From: Ellen Senior
Sent: 30 October 2023 12:04
To: [REDACTED]
Cc: Munira Patel
Subject: RE: Preliminary Consultations - Proposed diversion of public footpaths E53 and E54 (parts) at Edmonthorpe, in the Parish of Wymondham, and the Borough of Melton - MP/HTWMT/5612

1. CTC Correspondence

**SECTION 119 - HIGHWAYS ACT 1980
PROPOSED DIVERSION OF PUBLIC FOOTPATHS E53 AND E54 (PARTS) AT EDMONTHORPE,
IN THE PARISH OF WYMONDHAM, AND THE BOROUGH OF MELTON
PUBLIC PATH DIVERSION ORDER 2023**

An application has been received for the diversion of public footpaths E53 and E54 at Edmonthorpe, in the parish of Wymondham, and the borough of Melton as shown on Plan No. 2647 attached hereto.

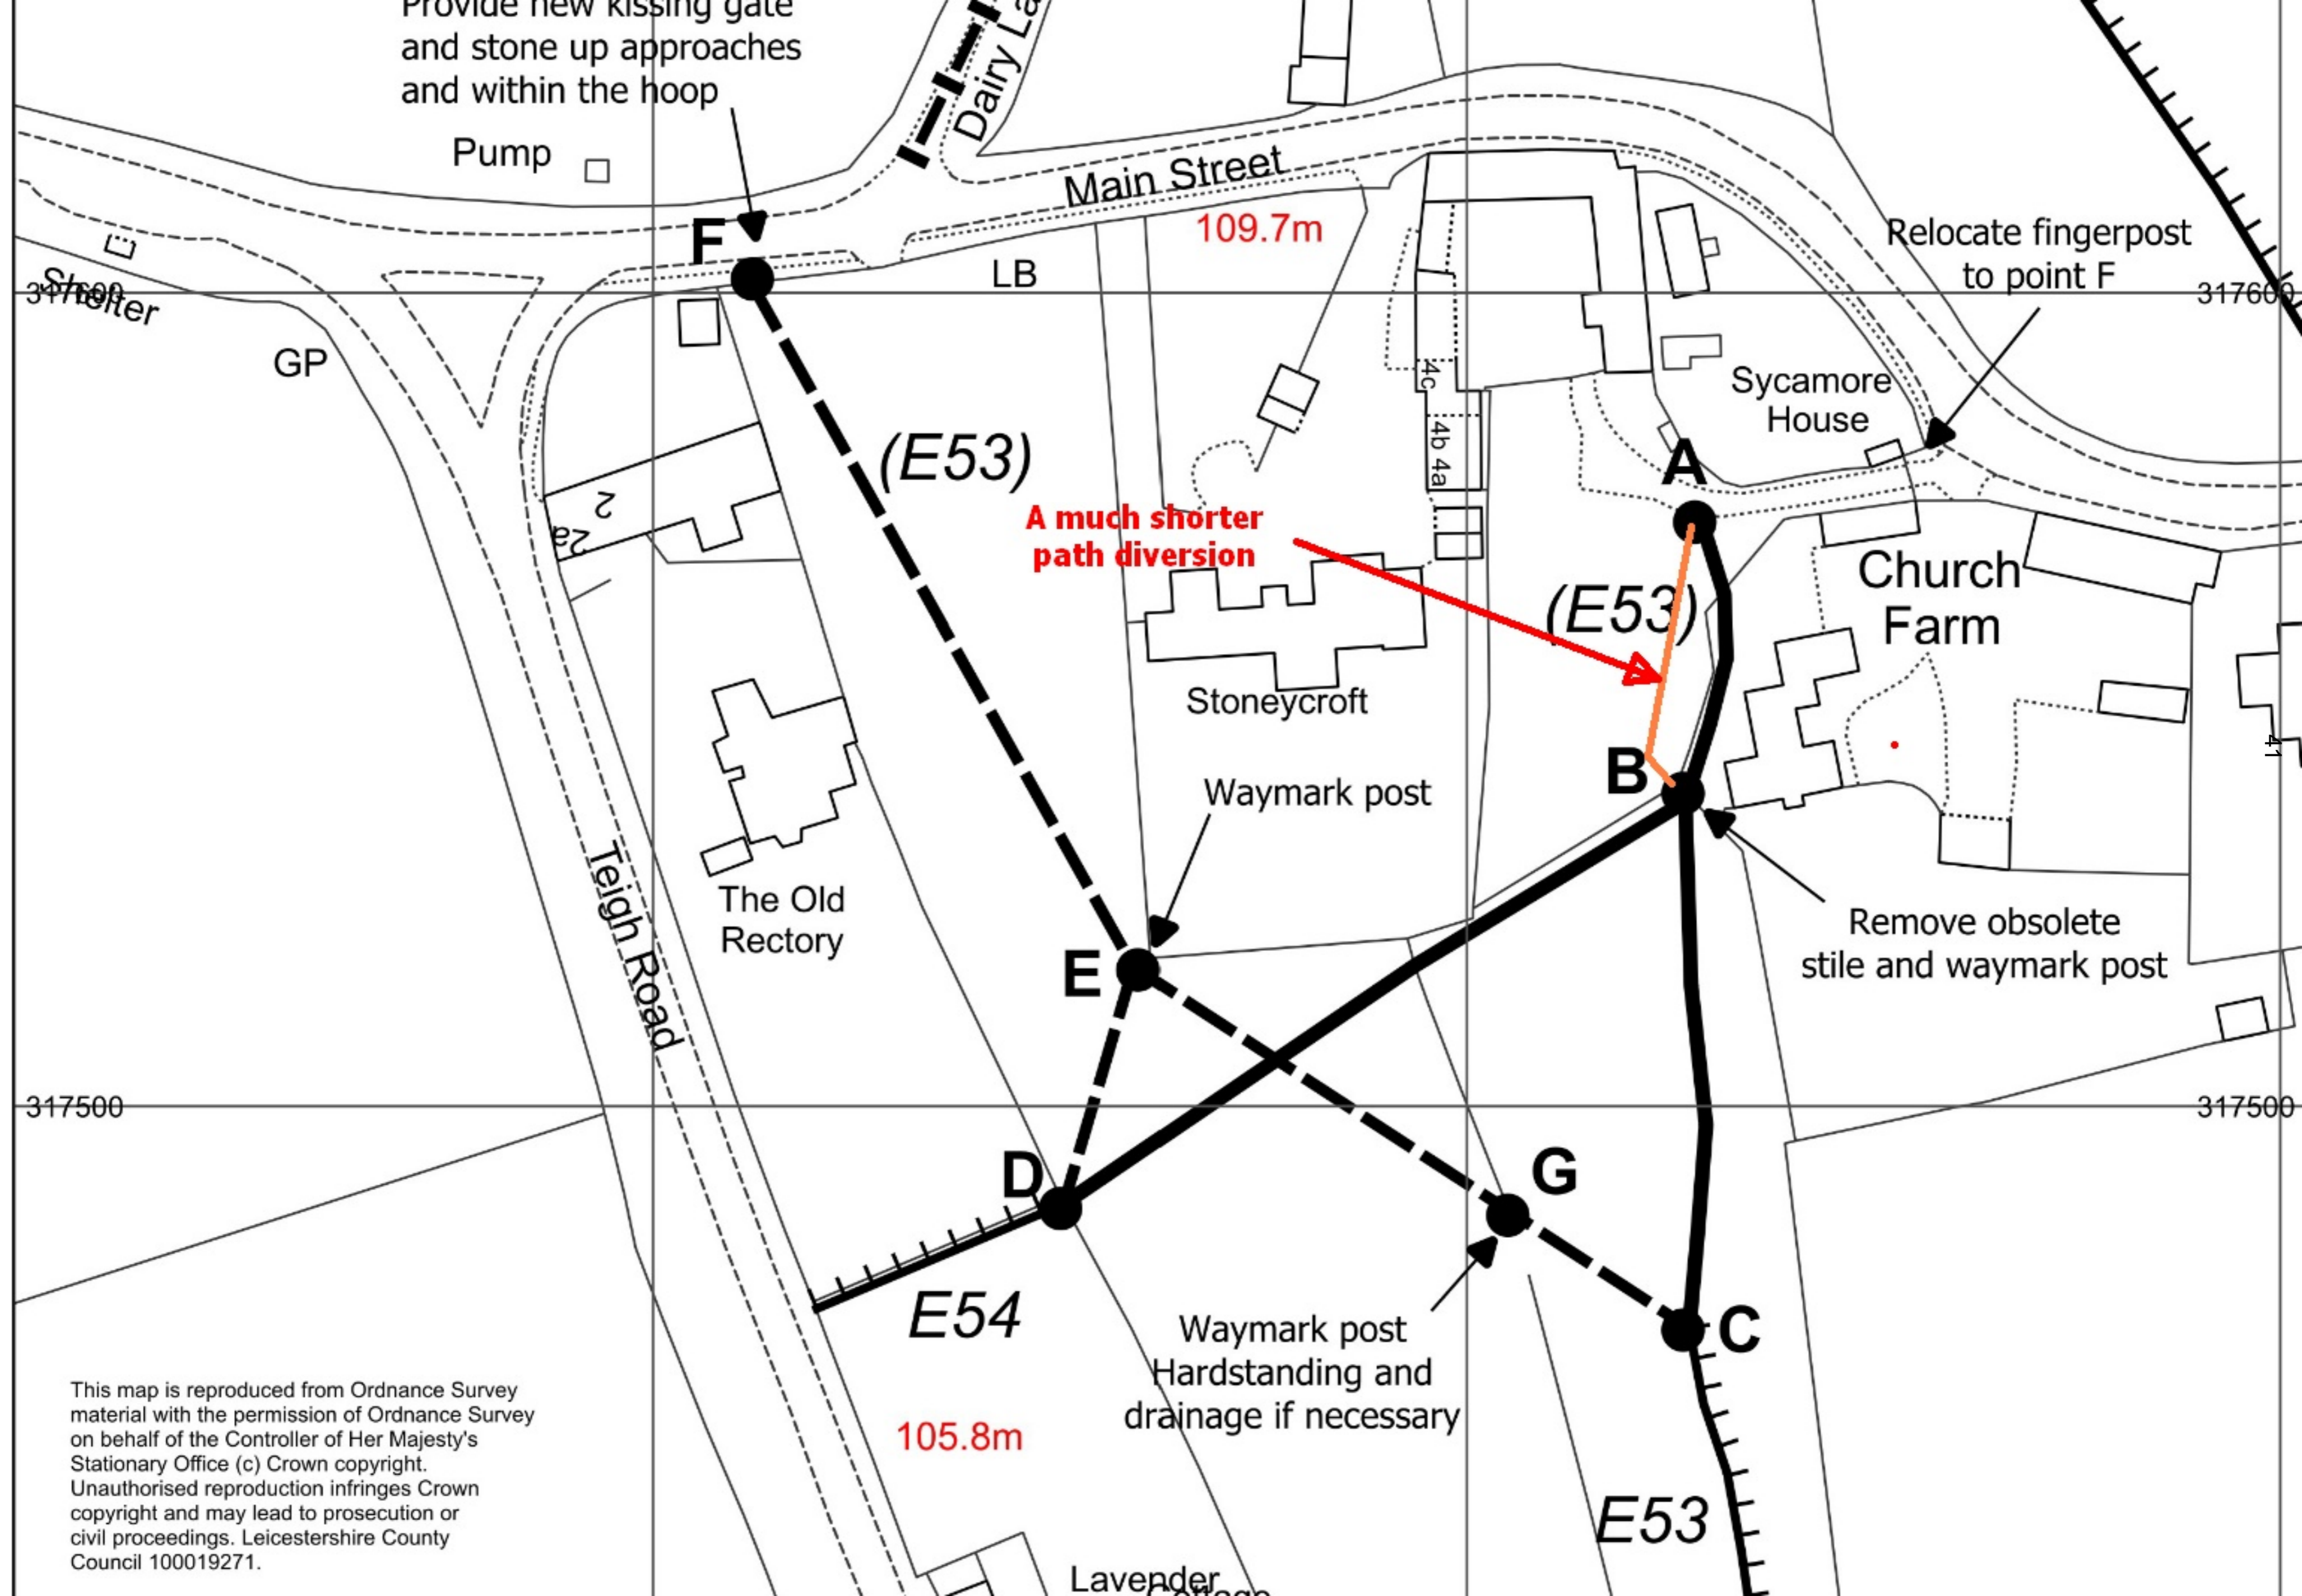
This seems a very convoluted plan just to move a footpath a bit further from a house.
Why not use a diversion similar to the one I have drawn on the plan in orange, going from point B to point A on the other side of the fence / wall? After all point A is already in it.

Leicestershire Footpath Association objects to this application. We agree that the proposed diversion would be more convenient for walkers who wish to proceed from E53 and E54 onto E46 going northwards (or vice versa). However, it is clearly less convenient for walkers who wish to access the village, or villagers who wish to access that part of the footpath network. And the arguments in favour of diverting it away from the applicant's property are not strong. On balance, therefore, we oppose the application. I have had some prior contact from the applicant's agent and I have let her know our thinking as a matter of courtesy.

Thank you for your comments on the proposed diversion of Footpath E53 at Edmondthorpe, I can understand your thoughts when looking at the map. However, there are two or three reasons why it wasn't so straight forward to pick an alternative route for the footpath.

The boundary between the two properties of Church Farm and Stoneycroft largely consists of an old retaining wall. Between A and B the footpath drops down. To follow your line would mean knocking a gap in the wall at point B and possibly steps or construction of a slope which would be quite an engineering job. Added to that is the fact that Edmondthorpe is a conservation area and alterations to the wall may not be looked on favourably.

Aside from those practical reasons, you may not be aware, but at the moment the Footpath finishes at point A which does not in fact connect to the recorded highway network. There is a "missing link" between point A and Main Street. Moving the exit of the Footpath to point F solves this anomaly and legally reconnects the footpath to the road.

There are always pros and cons in looking at a proposed diversion and in this case the onward connection to Dairy Lane and resolution of the missing link, added to the landowner's initial request and practicalities seems to weigh in favour of the proposal.
